**RECALL CAMPAIGN  
INSTRUCTIONS**

**REF. NO. C24100080**

**REPLACEMENT OF BRAKE FLUID  
RESERVOIR CAP**

**MODEL YEARS 2019 - 2022**

New Adhesive Sticker

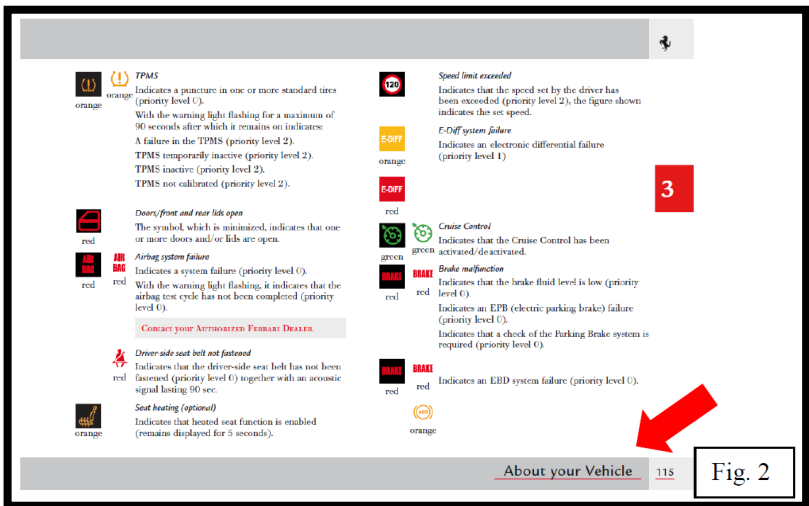
Please find below the proper location and instructions on how to insert the provided sticker into the Owner's Manual (PN: 079641778)

The sticker must be placed on the page shown above in the Owner's Manual. This page is located in the *"About Your Vehicle"* section where the warning lights on the instrument panel are described. Please be sure to attach it to the page with the *"Low Brake Fluid"* description as shown above in Fig. 2.

Once you locate the proper page, remove the adhesive protector off of the back of the sticker. Ensure there is no residue or other particles on the page that may inhibit the longevity of adhesion to the page. Place the sticker to allow the bottom of the sticker to lay directly above the gray margin at the bottom of the page that contains the text *"About your Vehicle"*.
